Department of Energy Responses to the Nuclear Regulatory Commission Request for Additional Information on the Draft Waste Incidental to Reprocessing Evaluation for Vitrification of Low Activity Waste

Prepared for the U.S. Department of Energy
Assistant Secretary for Environmental Management

D. B. Darling
Washington River Protection Solutions

Figure 2-3-1. Two-Dimensional Vertical Cross-Section Model of Integrated Disposal Facility Showing Numerical Grid and Surface Barrier Materials.

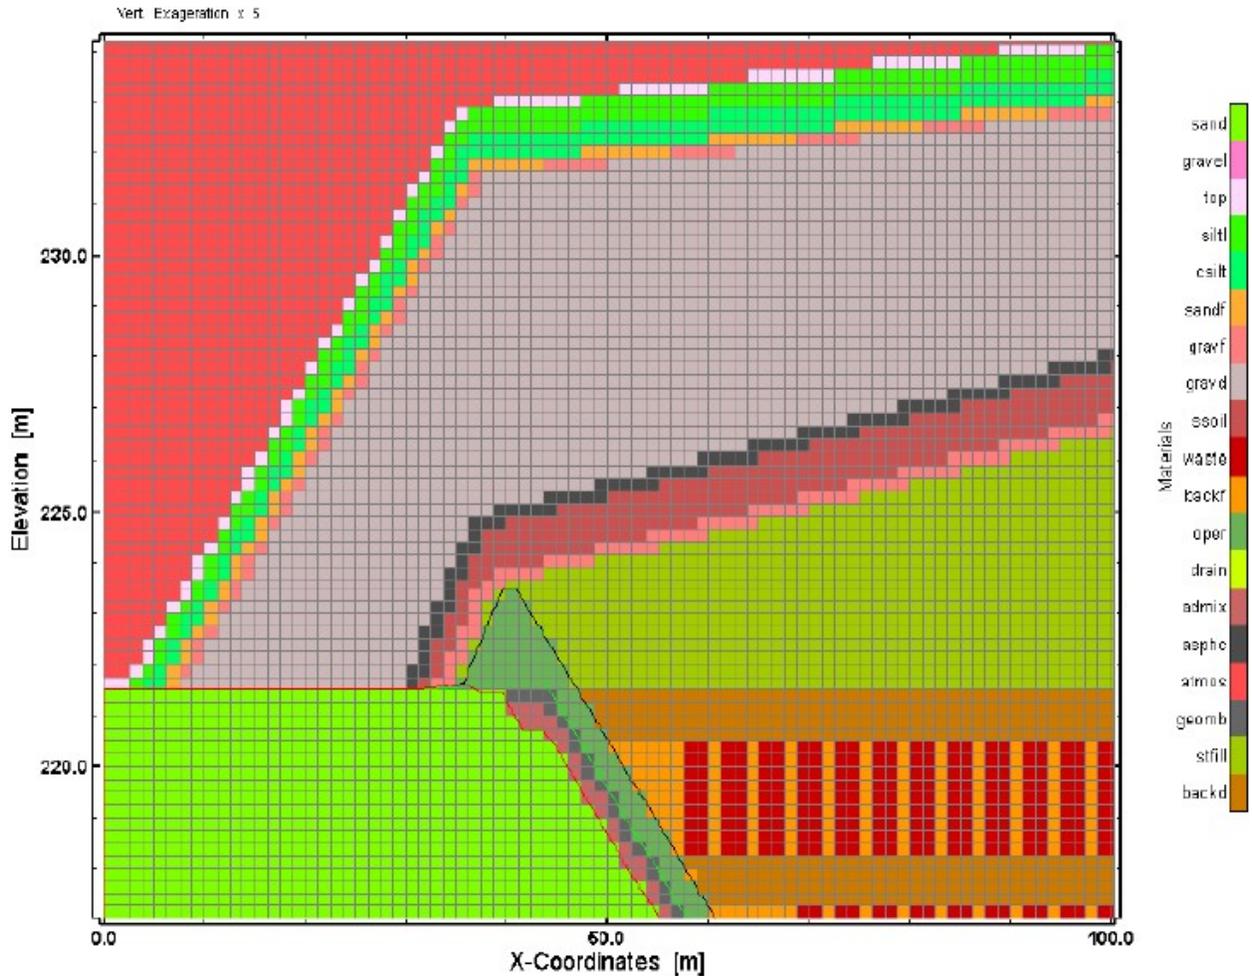
Figure 4-22 from the PA document (shown below), provided the numerical grid and material properties assigned for near-field flow. It appears that some layers are not continuous in the model. It is not clear how the discretization was fine enough to ensure proper precision. The text of the PA document describes the stair-stepped discretization but does not explain how it was determined that the model discretization was sufficient. The potential impact is shown in Figure 5-11 from the PA document (partial figure provided below) where the saturation values and liquid flux rates appear to have large variations as a result of the numerical grid selection.

DOE described the discretization of the model for glass degradation on page 5-49 of the PA document. An attempt was made to strike a balance between computational time and accuracy. Modeling with a 2 cm by 2 cm grid spacing resulted in execution times of over a month per simulation. The resultant fractional release rate (FRR) from the glass was 26% higher than the coarser grid, which DOE did not believe was significant in the context of performance assessment uncertainties. A 2 cm grid spacing is extremely coarse to represent the processes occurring at the glass/engineered system interface. Layers that are tens of microns thick can significantly influence the ingress and egress of species at the interface. With only two data points with respect to the influence of grid discretization, it is unknown how much the FRR's will increase as the grid spacing is further refined and at what point further refinement will have a minimal impact.

DOE acknowledges that the discontinuous layers of the engineered surface barrier in the two-dimensional (2D) near-field flow model depicted in RPP-RPT-59958, Figure 4-22 do not physically represent the continuous layers that would be constructed in the barrier above the IDF. The discontinuous nature of the model layers in the surface barrier are a result of the selected grid size used to represent the engineered surface barrier, but DOE believes that the grid size was adequate for the intended purpose of the model, which was to investigate moisture distribution in the vicinity of the waste containers and through the IDF liner system. The simulation results were then used to develop boundary conditions for radionuclide fate and transport simulations; the near-field flow model was not used to simulate radionuclide fate and transport.

Figure 2-4-1. Grids for Alternative Disposal Configurations Involving One Waste Package or Four Vertically Stacked Waste Packages.

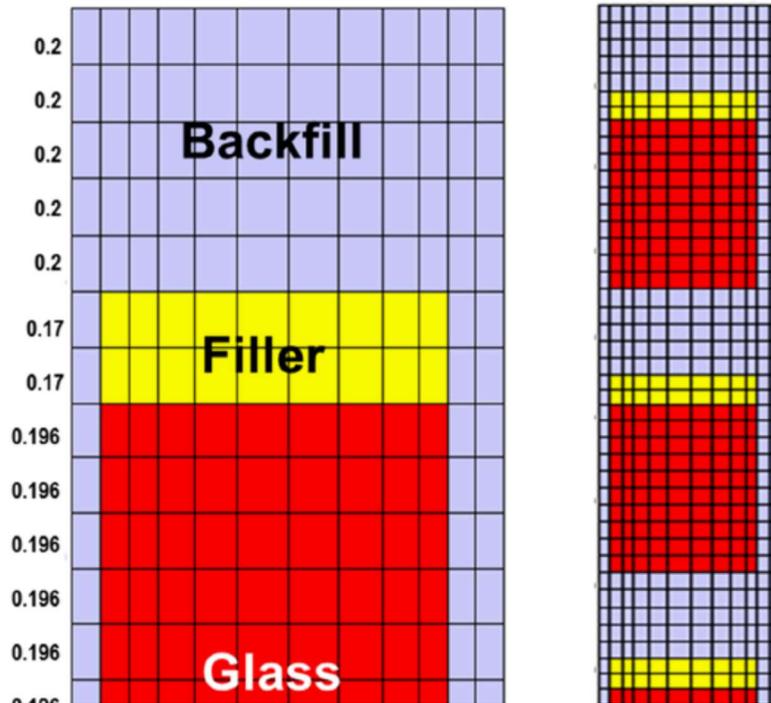
Throughout the PA document (for example page 5-19), DOE indicated that highly permeable layers, such as the drainage layers, act as capillary barriers under most conditions. In addition, Table 5-14 showed that the simulated flux of water through the wastefrom is approximately ten times less than the infiltration rate. Adequate model support was not provided for the simulated capillary barrier effects provided by the modeling. The figure below (Figure 5-1 from RPPCALC-61031) shows the coarse discretization and discrete layers used in the near-field modeling. It isn't clear how much of the observed reduction in flow through the wastefrom is a result of the modeling approach selected.

In the real system, a fractured glass surrounded by soil will have some of the fine-grained soil that infills the fractures at the boundary of the glass (NRC notes that the glass is contained in a stainless steel canister and DOE has elected to ignore the effects of the canister). When finer scale modeling is used, water that flows along the surface of the unfractured glass will enter the fractures and saturations can build up locally resulting in dynamic rivulets of flow which otherwise would not be observed in the coarse-scale modeling with large timesteps. In addition, the MCC parameters have natural variability which is not represented in the DOE modeling approach where uniform properties are prescribed for every cell of a given material type. Modeling of the capillary barrier effect using heterogeneous properties showed much earlier breakthrough of moisture than would be estimated using homogeneous properties (Ho and Webb, 1998).

Figure 2-7-2. Normalized Glass Dissolution Rate, Based on Boron, as a Function of pH(T) for LAWA44.

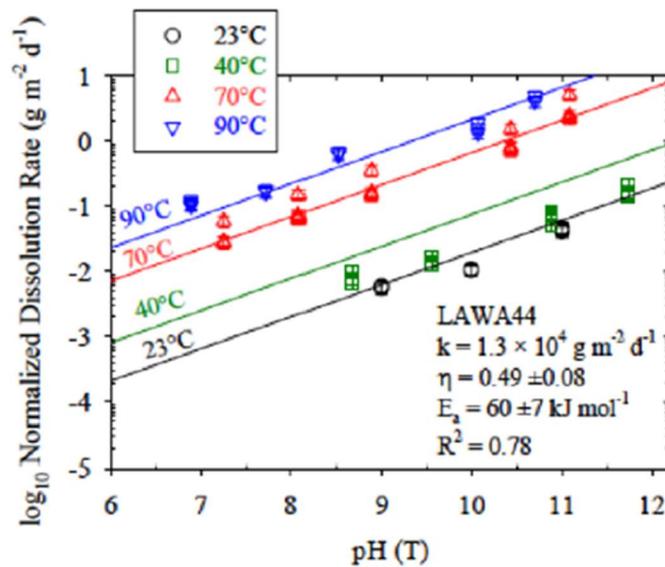
Figure 4-7 from PNNL-24615 has a relatively poor fit of the data at 40 °C, which impacts the uncertainty assigned to the coefficients. When NRC staff attempted to use a broader range for activation energy in the FRR regression equations in order to understand the significance of the uncertainty the expression yielded non-physical results. Table 4-1 from PNNL shows the derived parameters for the different glass compositions. As implemented in the PA, the three most important parameters (the forward rate constant (k_o), the glass apparent equilibrium constant (a), the Na ion-exchange rate (r_{IEX})) were all fixed as constants. Even if the previously discussed shortcomings are dismissed, some of the derived parameters have R^2 of only 0.78 on a logarithmic scale.

Figure 2-15-1. Fitted Log-Normal Distribution to the van Genuchten “Alpha” Parameter Data Set Used for the H2 Unit.

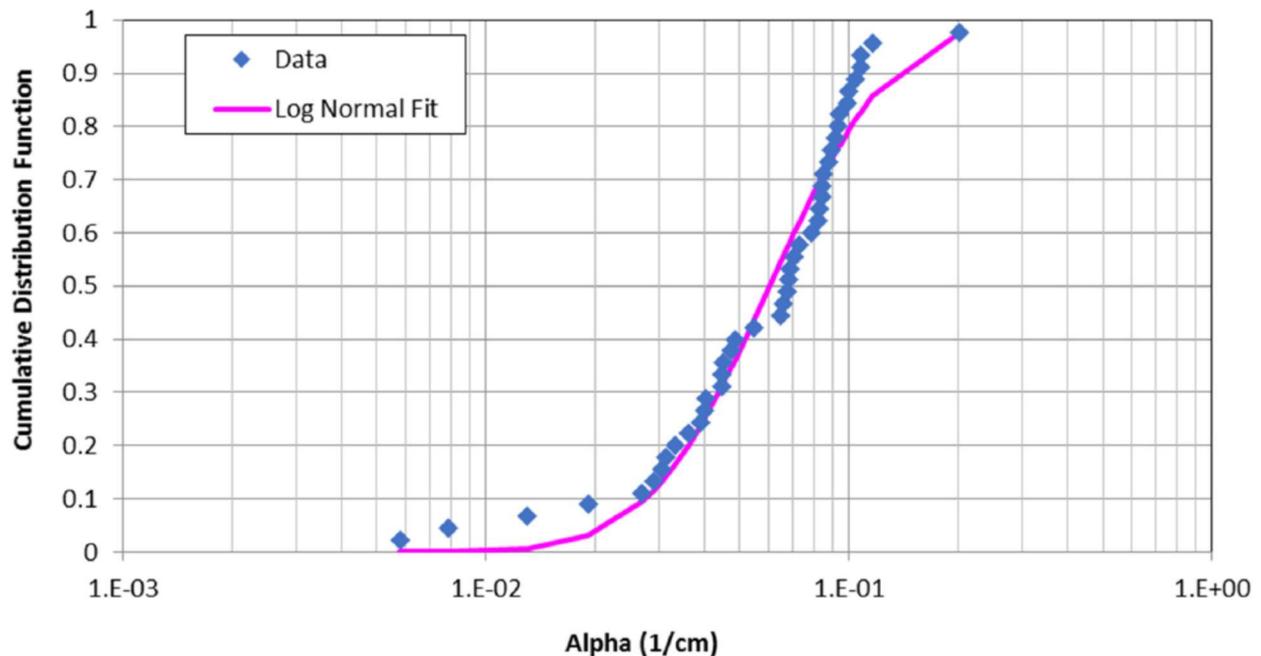
To develop uncertainty distributions of unsaturated flow parameters the empirical data were fit with statistical distributions. The van Genuchten alpha parameter for the H2 unit was assigned a log-normal distribution. The fit of the equation to the data showed deviations at the tails of the distributions (See Figure 4-56 from the PA document provided below).

The approach taken in the IDF PA was to sample the five uncertain fitted distributions (like the example of the fitted distribution for the van Genuchten alpha parameter illustrated in Figure 4-46 [included in the RAI basis]) 200 times and then to calculate the moisture content for
